EPC STORMWATER REVIEW COMMENTS
IN ORANGE BOXES WITH BLACK TEXT

**FINAL DRAINAGE REPORT
FOR
PLATTE SELF STORAGE
COLORADO SPRINGS, COLORADO**

MAY 2024

TNE Job No. 2419.00
County Job No. ###
Please include project No.
PPR2418

Project: **Platte Self Storage** Location: **East Drain Trench (need Q=9.1 cfs)**
 By: **John Fornander** Date: **4/19/2024**
 Chk By: _____ Date: _____ version 12-2004

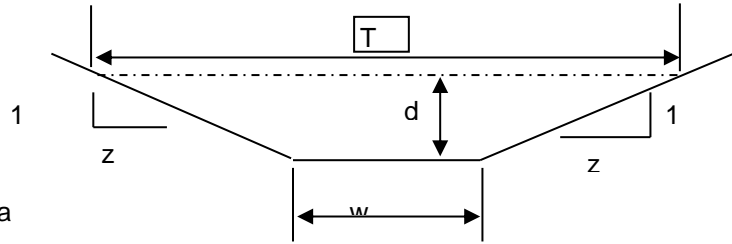
Please provide erosion protection for this open channel as velocity is above the standard velocity per DCM vol.1, chapter 10, table 10-4

TNES RESPONSE:
 This is a concrete-lined trench which provides sufficient erosion protection.

Project: **Platte Self Storage** Location: **Bldg N+RV Drive Aisel (need Q=31 cfs)**
 By: **John F** Date: **4/2/2024**
 Chk By: _____ Date: _____ version 12-2004

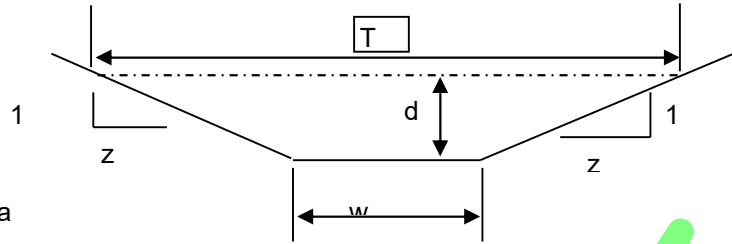
Please provide erosion protection for this open channel as velocity is above the standard velocity per DCM vol.1, chapter 10, table 10-4

TNES RESPONSE:
 This is a drive-aisle and flow is centered in a concrete cross-pan. This provides sufficient erosion protection.

Project: **Platte Self Storage** Location: **Bldg Central Drive Aisel (need Q=41.3 cfs)**
 By: **John F** Date: **4/2/2024**
 Chk By: _____ Date: _____ version 12-2004

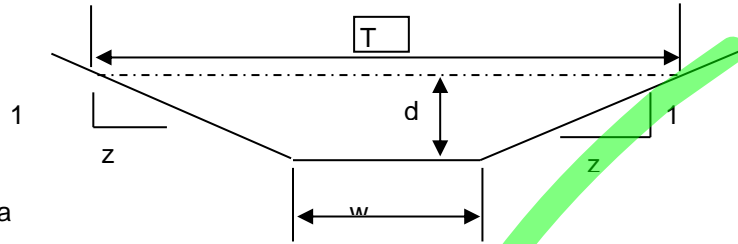
Please provide erosion protection for this open channel as velocity is above the standard velocity per DCM vol.1, chapter 10, table 10-4

TNES RESPONSE:
 This is a drive-aisle and flow is centered in a concrete cross-pan. This provides sufficient erosion protection.

Project: **Platte Self Storage** Location: **2' TRICKEL CHANNEL**
 By: **JS** Date: **4/29/2024**
 Chk By: **DF** Date: **4/29/2024** version 12-2004

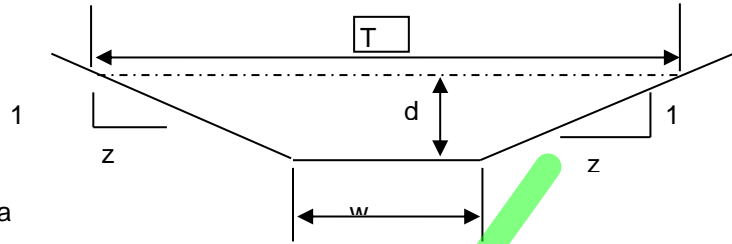
Please provide erosion protection for this open channel as velocity is above the standard velocity per DCM vol.1, chapter 10, table 10-4

Per DCMv2 – Chap 4.2, trickle channel should at a minimum provide capacity equal to twice the release capacity at the upstream forebay outlet. Provide these calcs in the drainage report and revise plans as needed.

TNES RESPONSE:
 This is a concrete trickle channel. This provides sufficient erosion protection.

TNES RESPONSE:
 Please compare trickle channel flow calculation with forebay notch release rate. Trickle channel flow is significantly higher than notch release rate, more than twice the capacity.

PLATTE SELF STORAGE SITE DEVELOPMENT PLAN PROPOSED DRAINAGE MAP MAY 2024

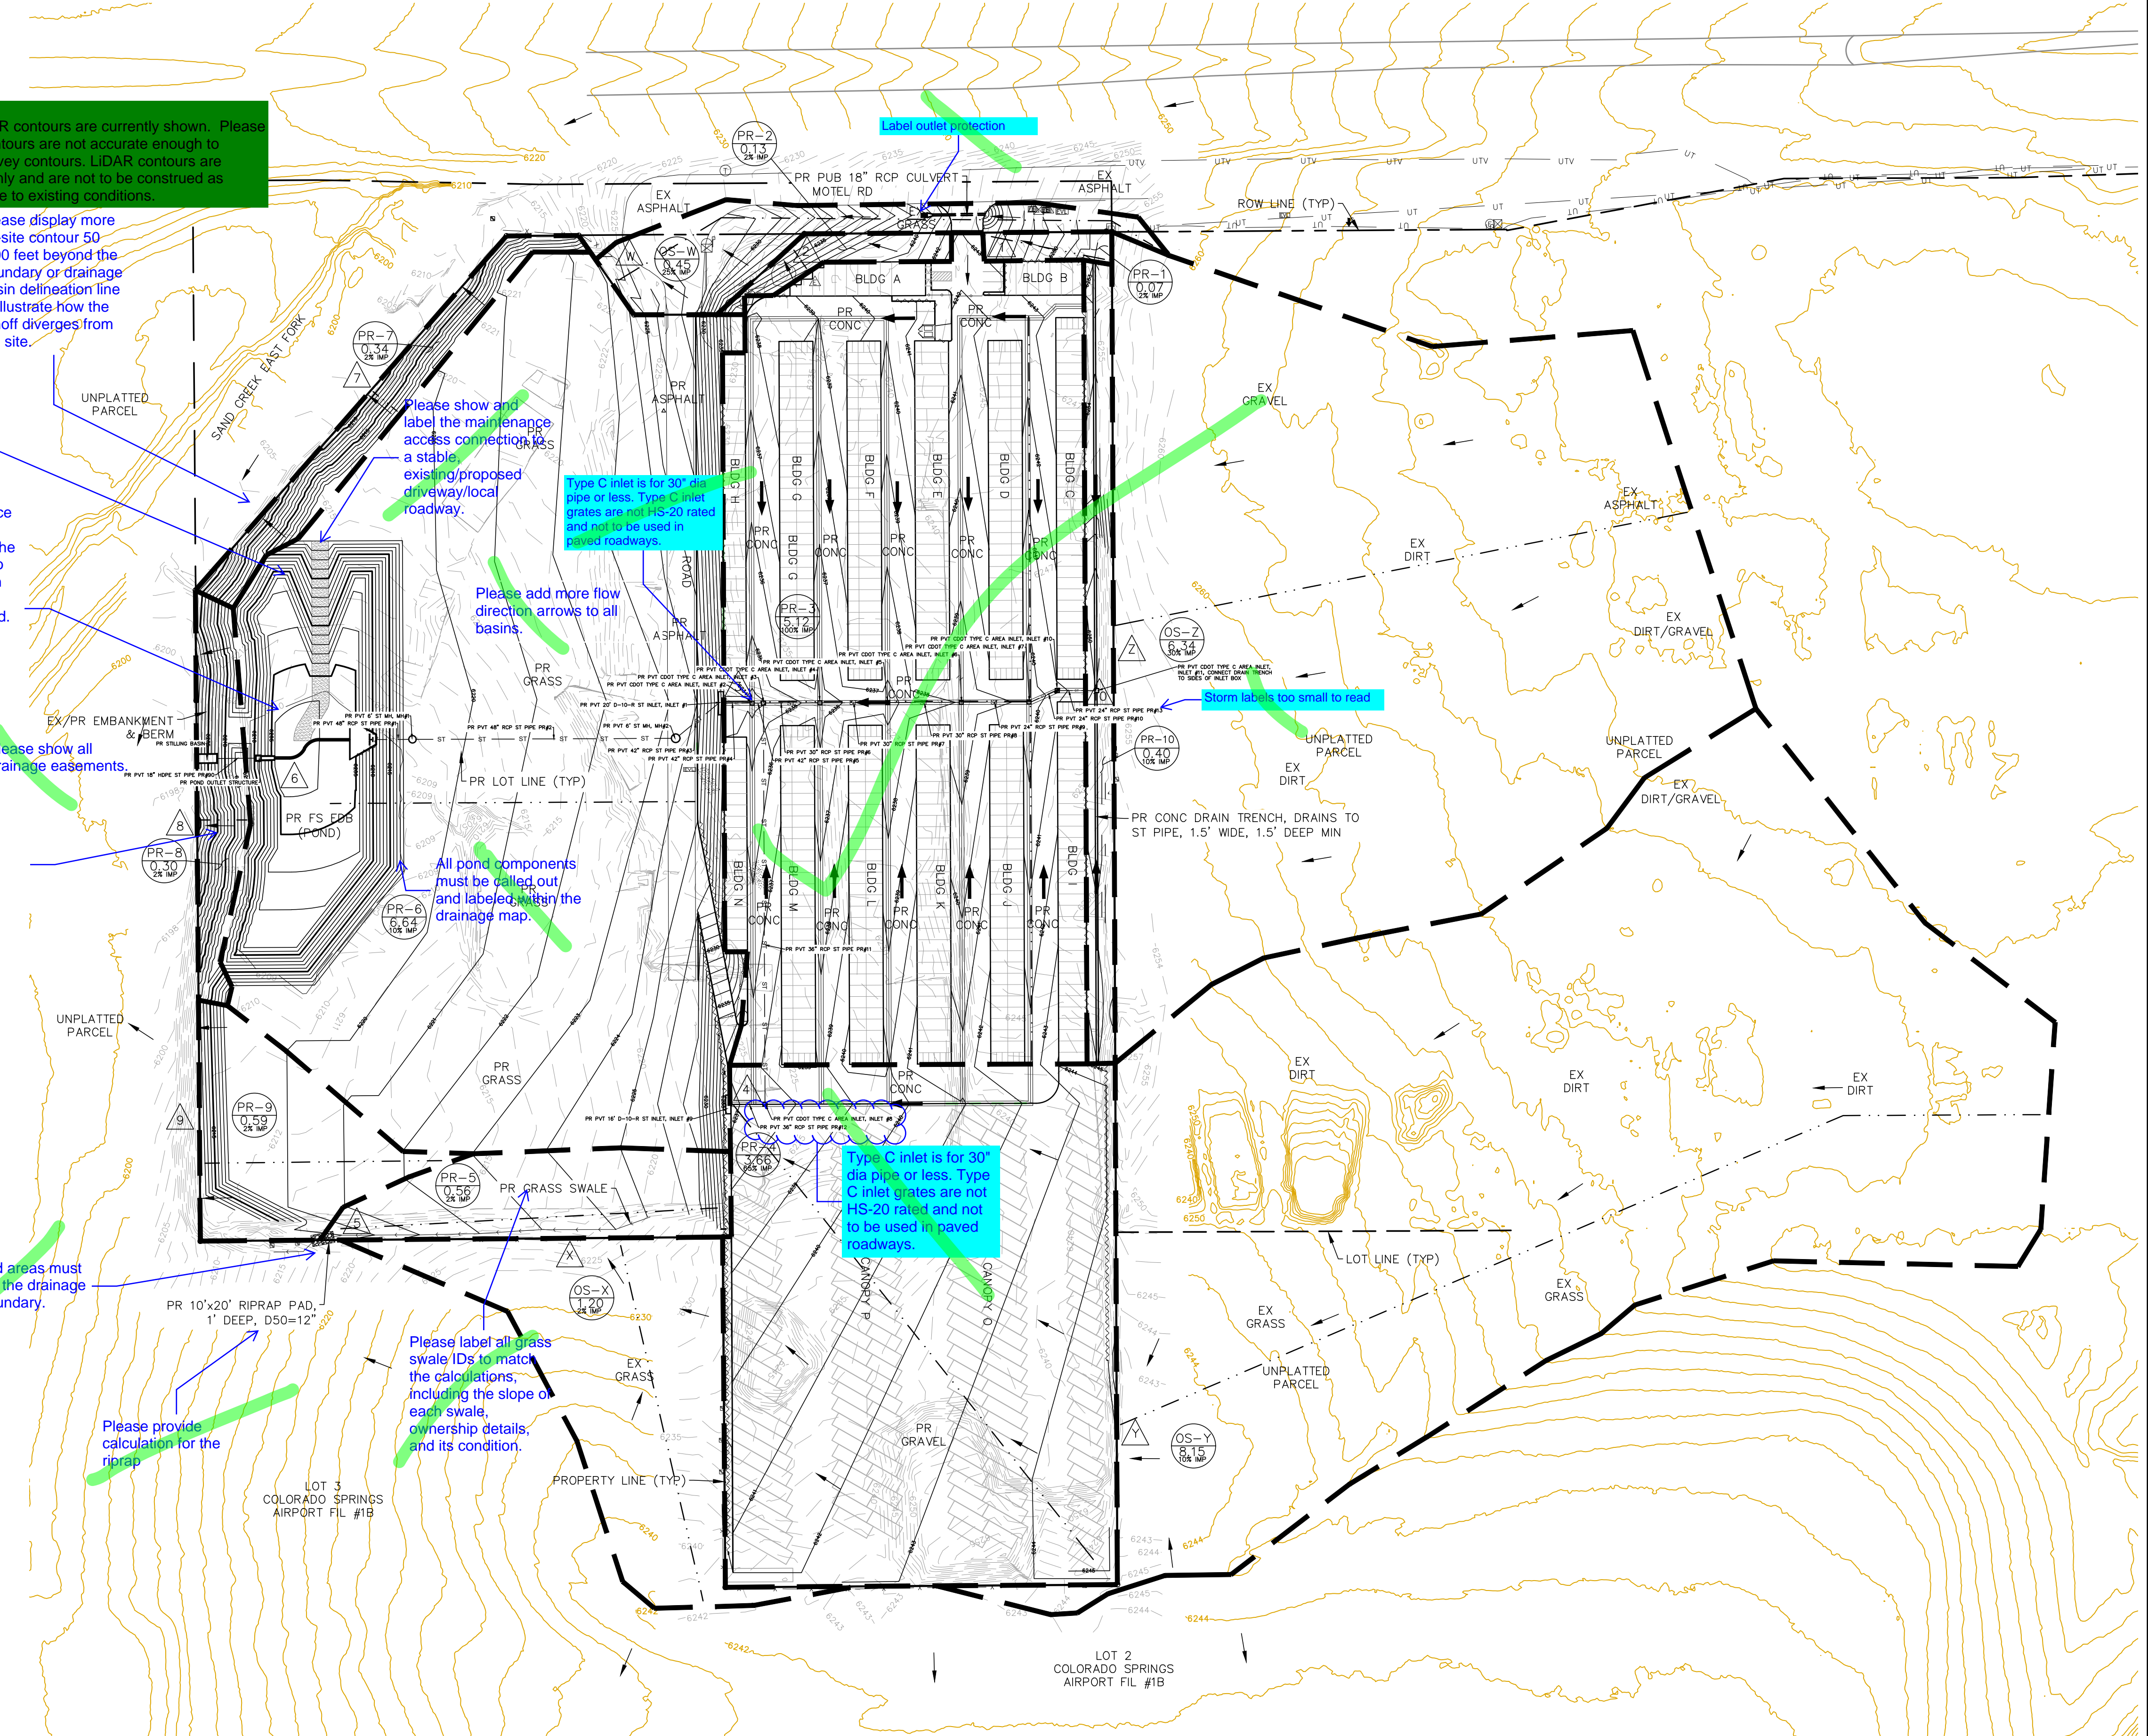
Please display more off-site contour 50'-200 feet beyond the boundary or drainage basin delineation line to illustrate how the runoff diverges from the site.

Please show and label all side slope of the pond. Side slope cannot be steeper than 3:1.

Please consider the distance between inlet and outlet. Distance measured along the trickle channel (from inlet to outlet) to the average basin width is at least 1.5:1, and greater than 2:1 is preferred. USDCM, Chapter 4, T-6.

Please show all drainage easements.

Please show and label spillway with type, size, and condition.

Disturbed areas must be within the drainage basin boundary.

Please provide calculation for the riprap.

Please label all grass swale /Ds to match the calculations, including the slope of each swale, ownership details, and its condition.

All pond components must be called out and labeled within the drainage map.

Please show and label the maintenance access connection as a stable existing/proposed driveway/local roadway.

Please add more flow direction arrows to all basins.

Type C inlet is for 30" dia pipe or less. Type C inlet gates are not HS-20 rated and not to be used in paved roadways.

Storm labels too small to read

Type C inlet is for 30" dia pipe or less. Type C inlet gates are not HS-20 rated and not to be used in paved roadways.

See comments on summary table in report

LINE RESPONSE:
50'-200' is where LIDAR contours are currently shown. Please see note 1. LIDAR contours are not accurate enough to properly tie into survey contours. LIDAR contours are provided for context only and are not to be construed as exactly true or accurate to existing conditions.
